**TRI-STATE GENERATION AND TRANSMISSION ASSOCIATION, INC.**

**RE: Colowyo Coal Company L.P.  
Permit No. C-1981-019  
Technical Revision No. 138  
Gossard and Rail Loop Ponds**

Revision Description: **TR-138 Gossard & Rail Loop Ponds**

**Figure 2**

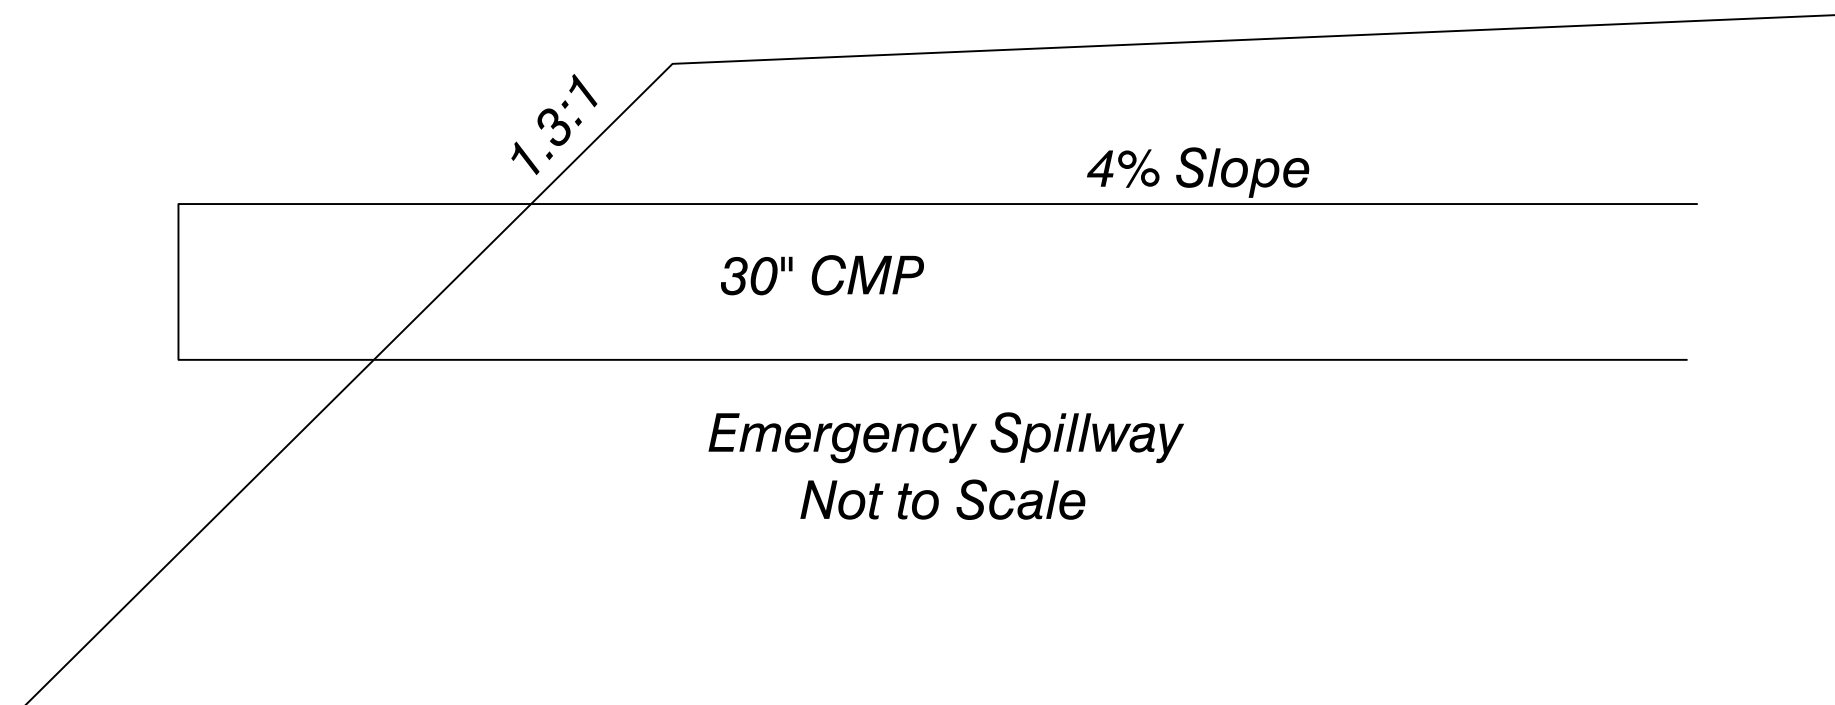
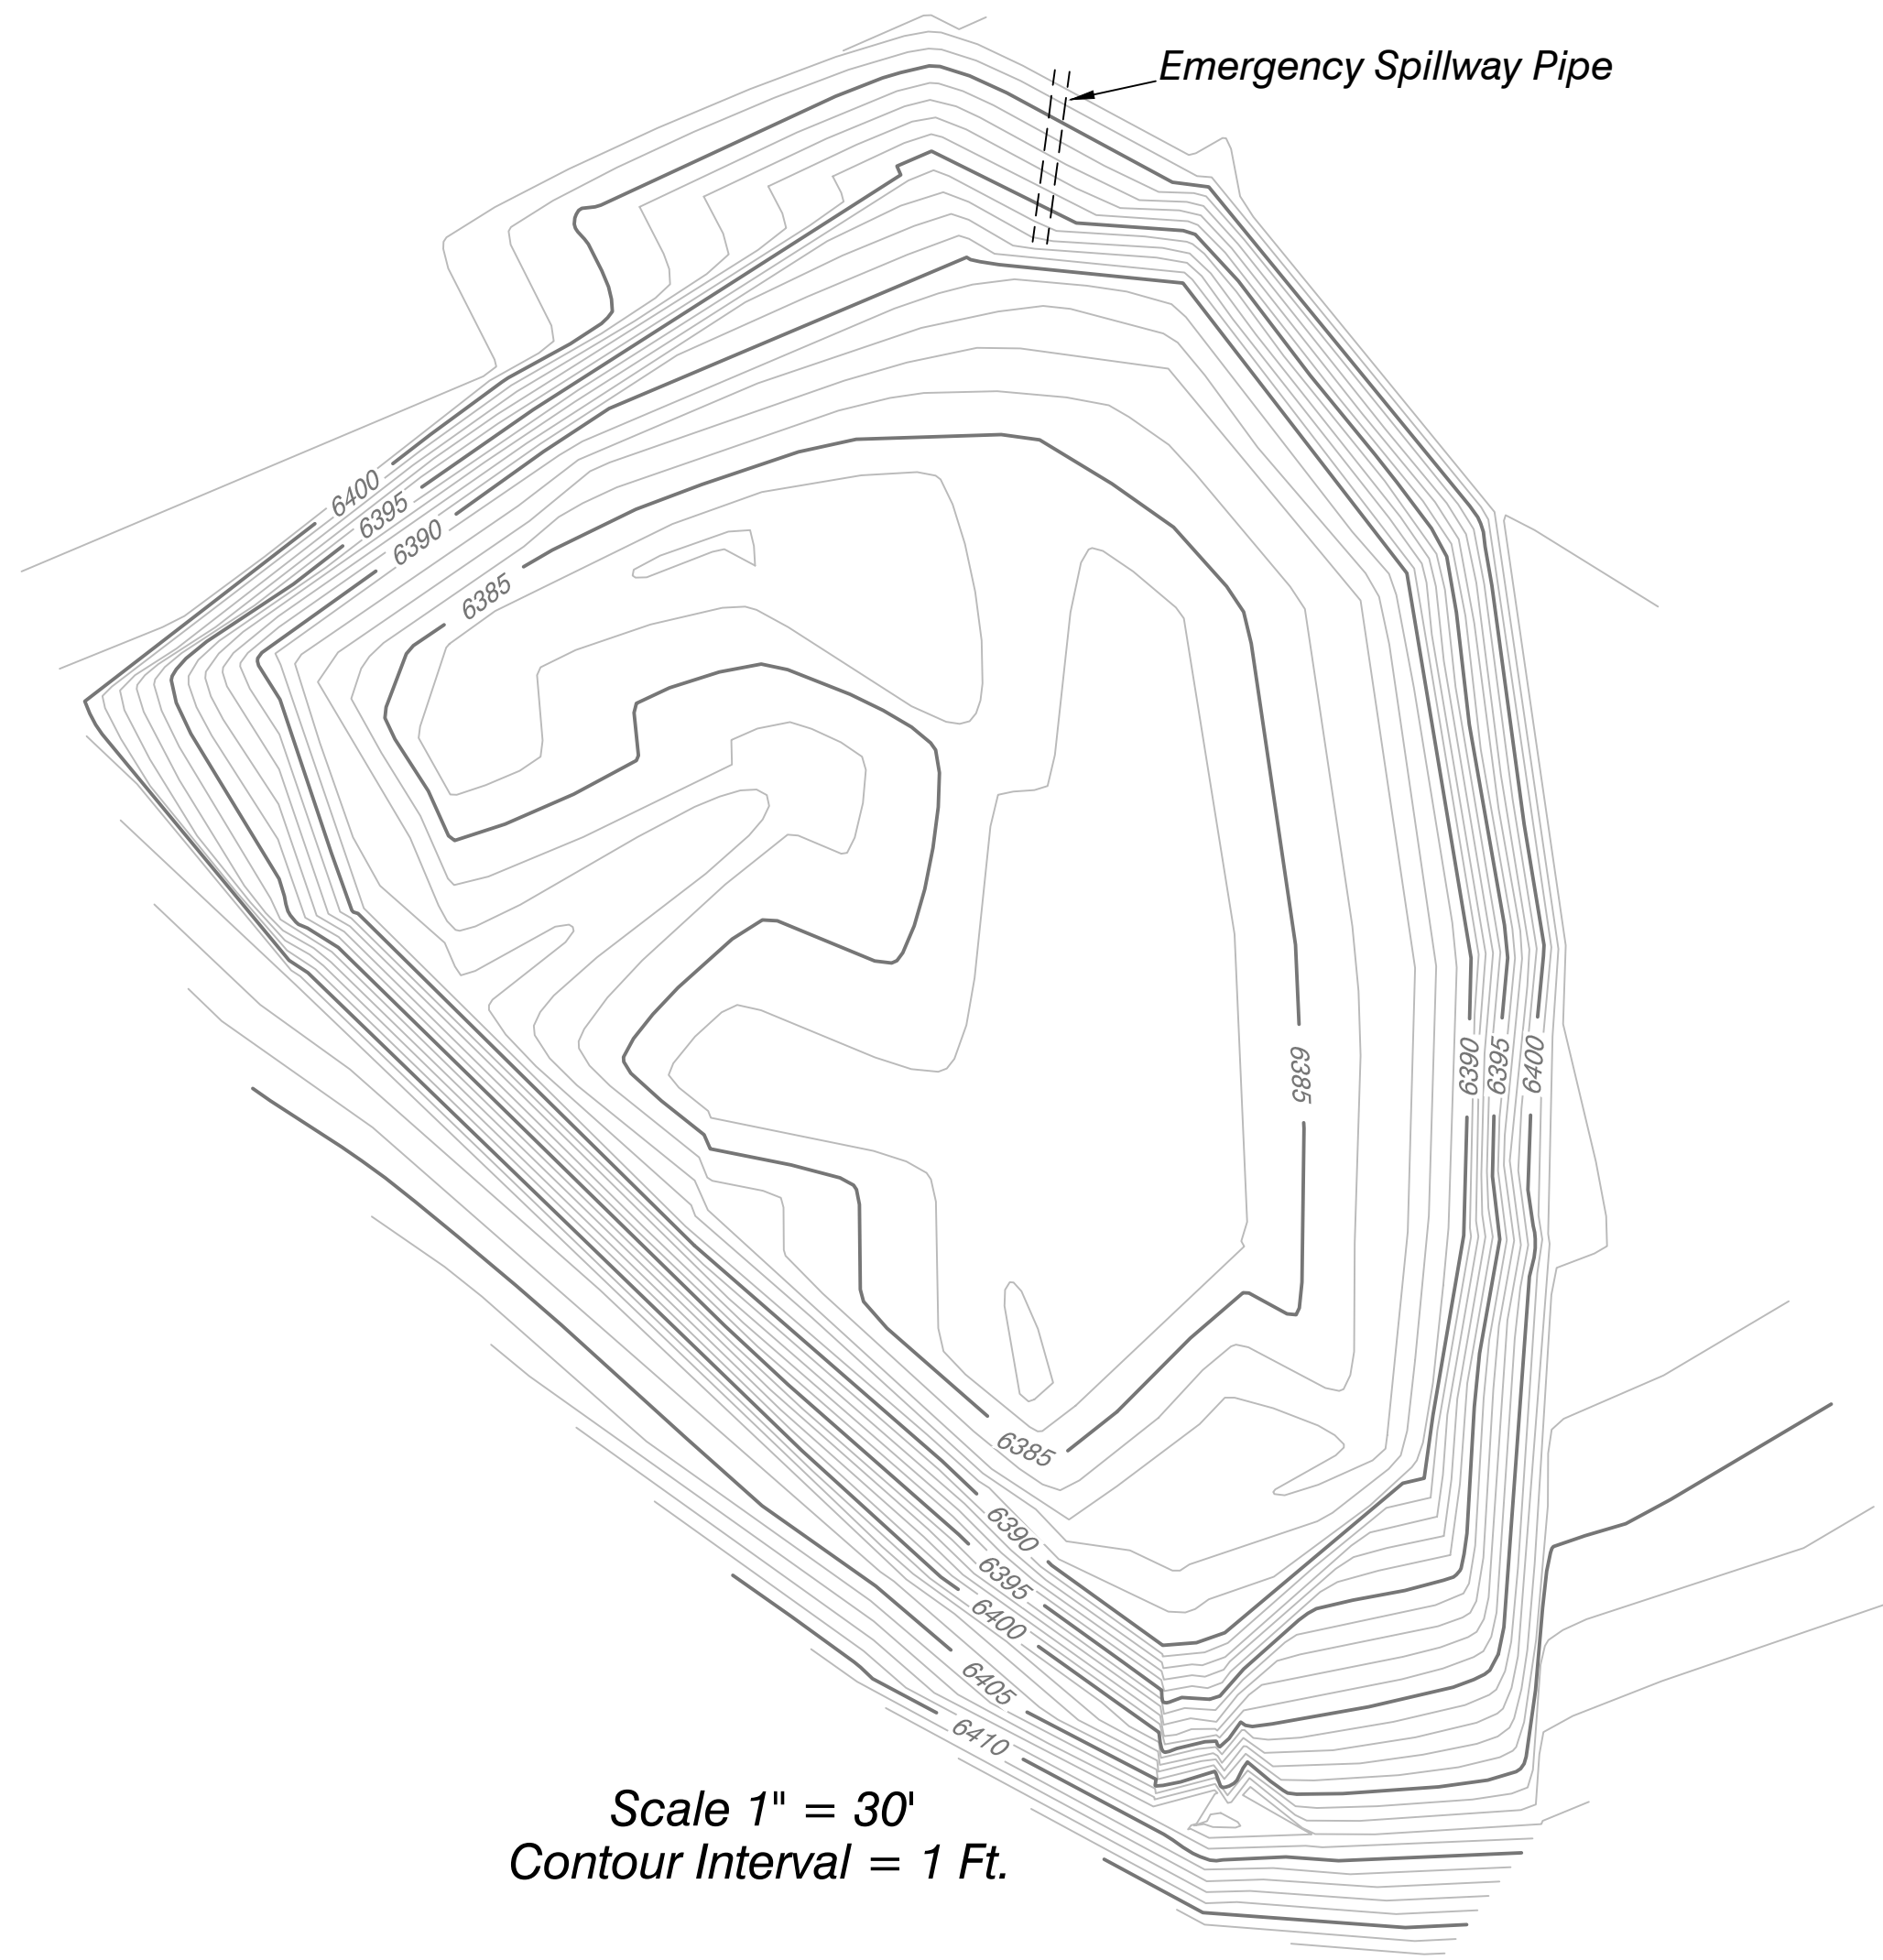
No.	REVISION	DATE	BY	CHK
1	As-Built	9/21/99	JPG SRH	JPG SRH
TR-138	Removed Primary Spillways, Updated Entire As-Built Format Updated Stage Storage Curves, Revised Drawing Size	4/29/20	Tony	BC

**Figure 2**

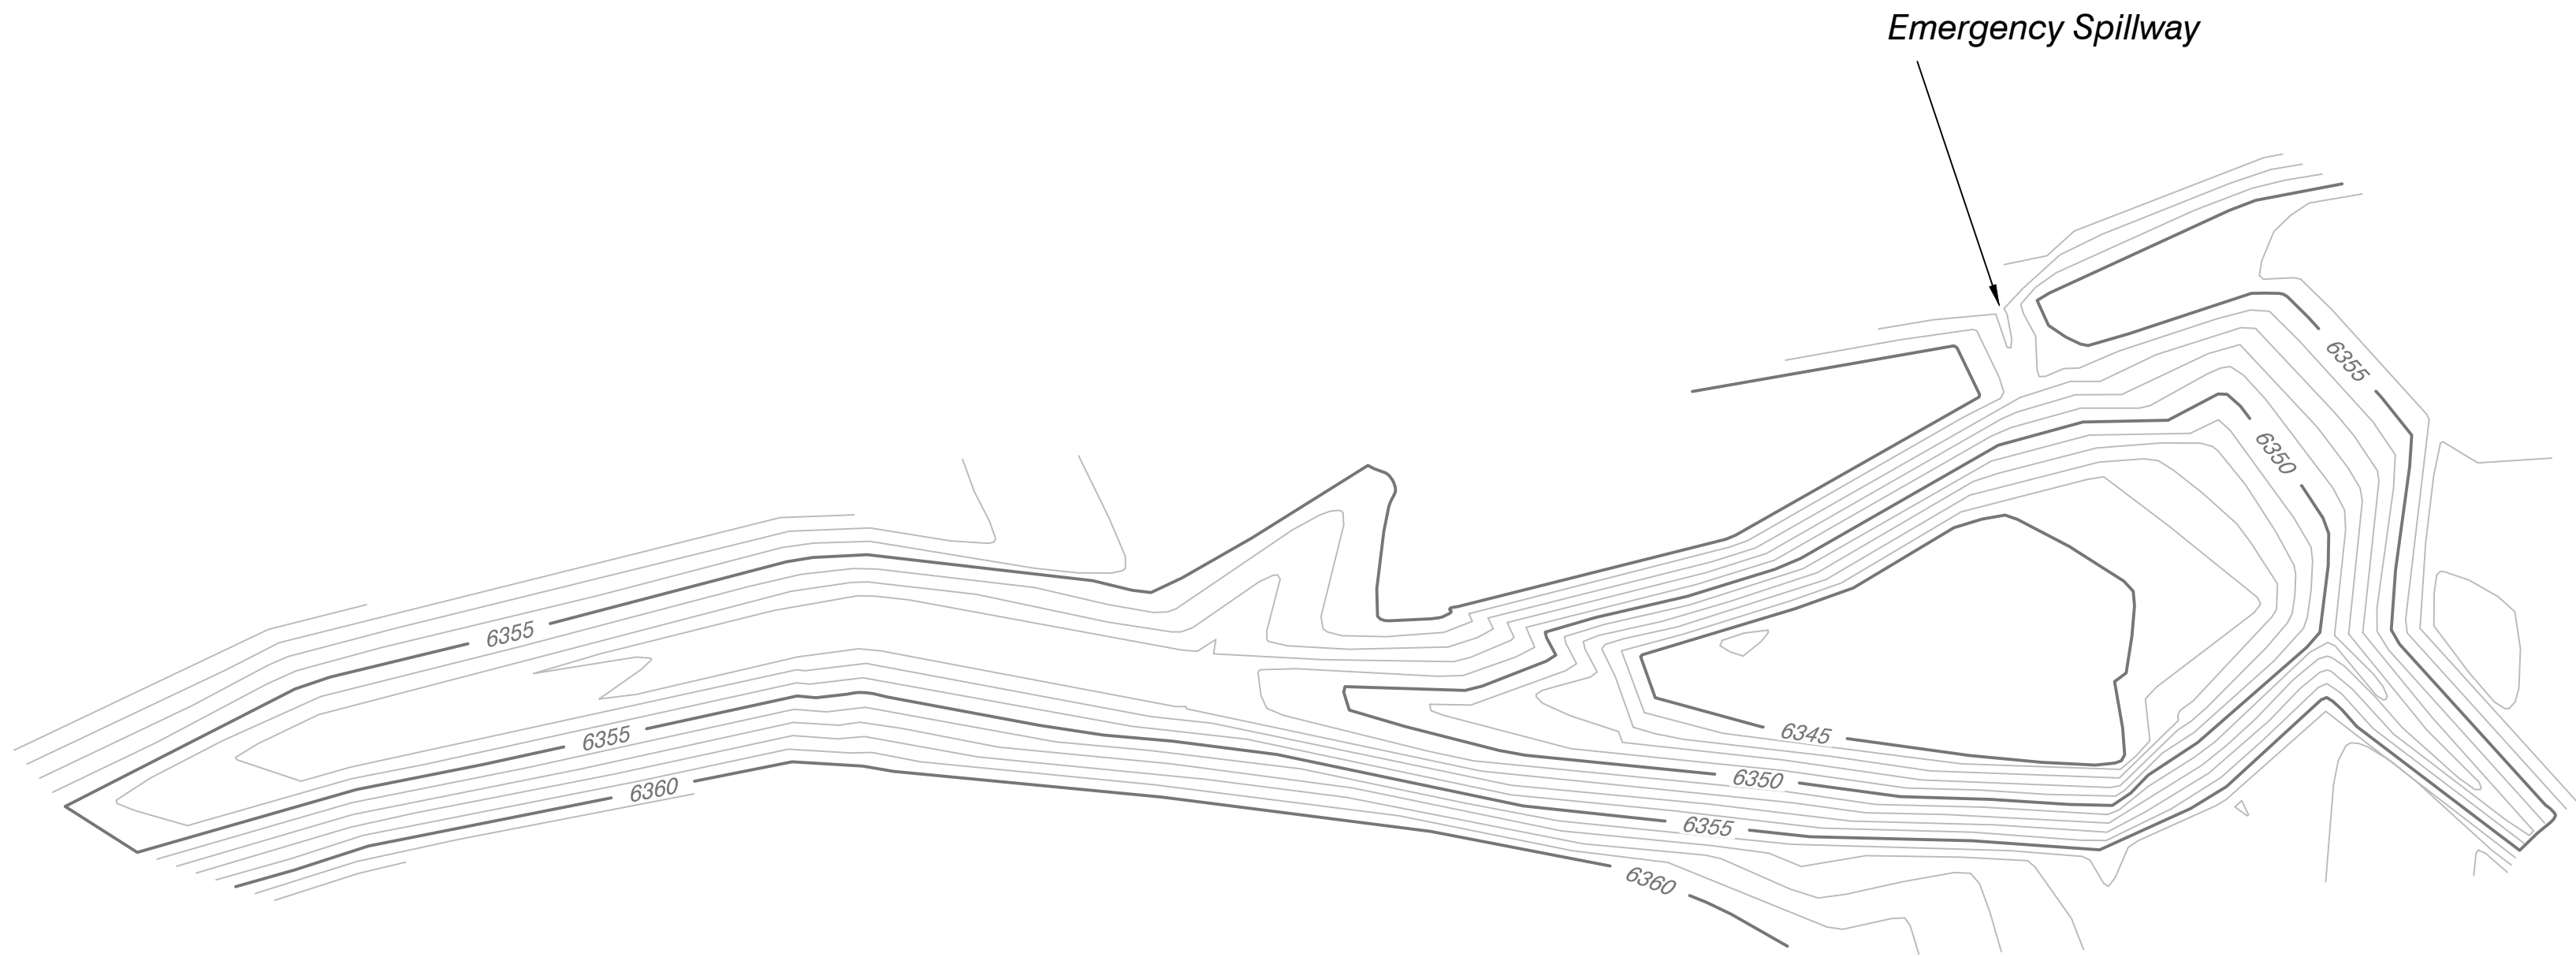
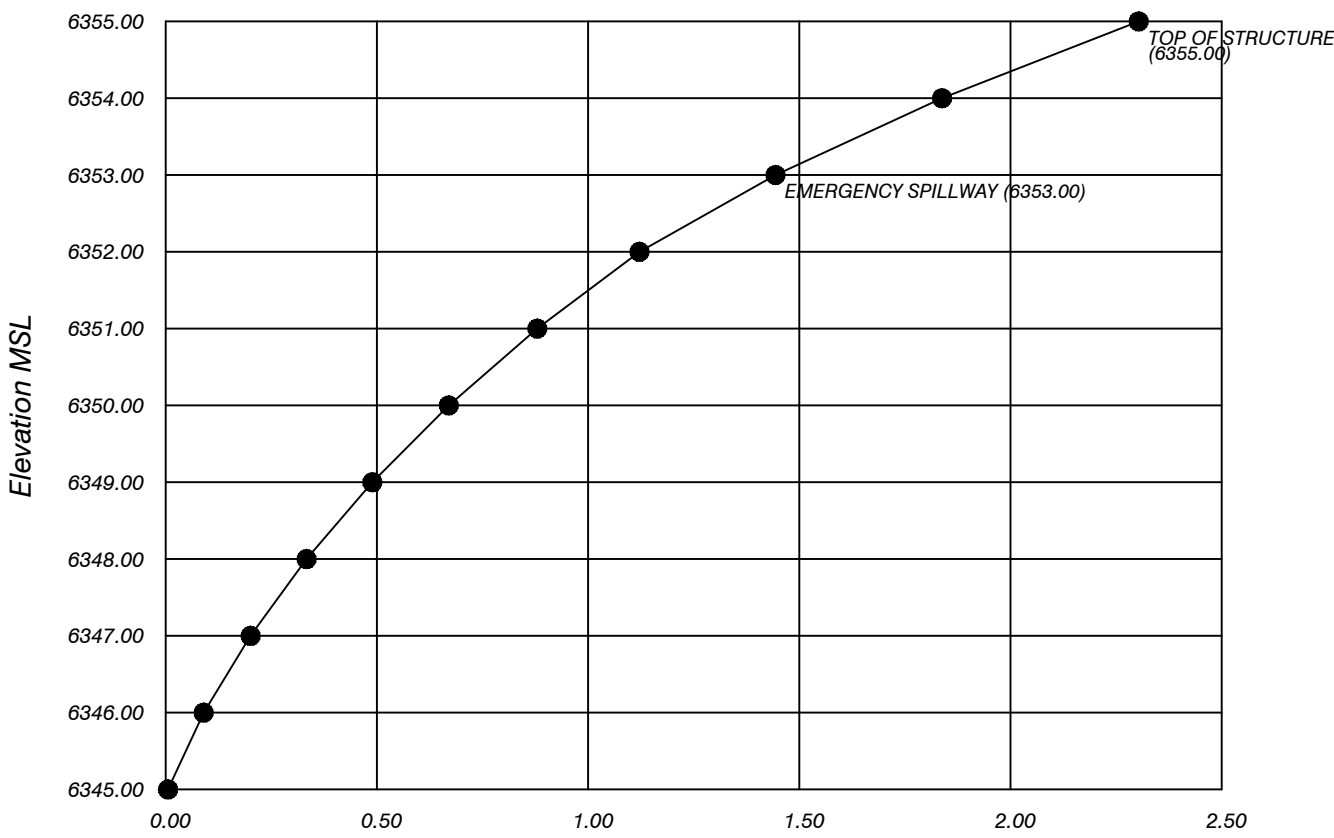
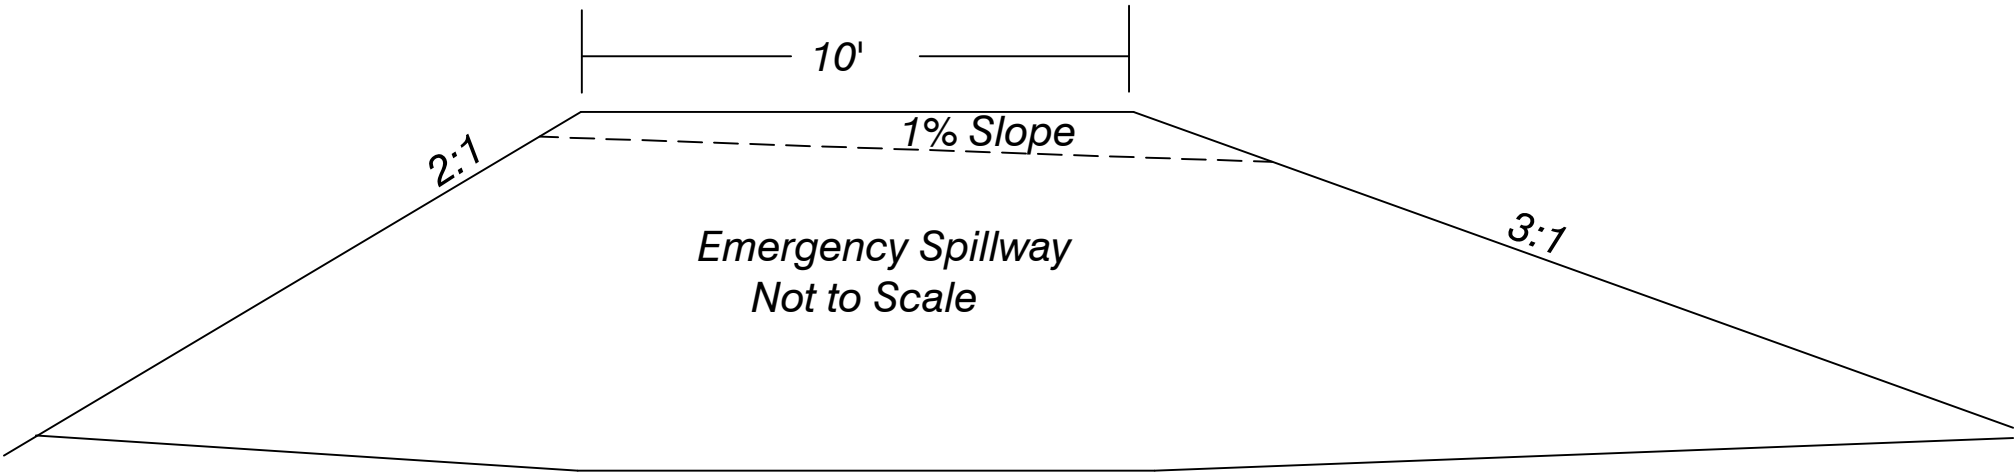
No.	REVISION	DATE	BY	CHK
1	As-Built	9/21/99	JPG SRH	JPG SRH
TR-138	Removed Primary Spillways, Updated Entire As-Built Format Updated Stage Storage Curves, Revised Paper Size	4/29/20	Tony	BC
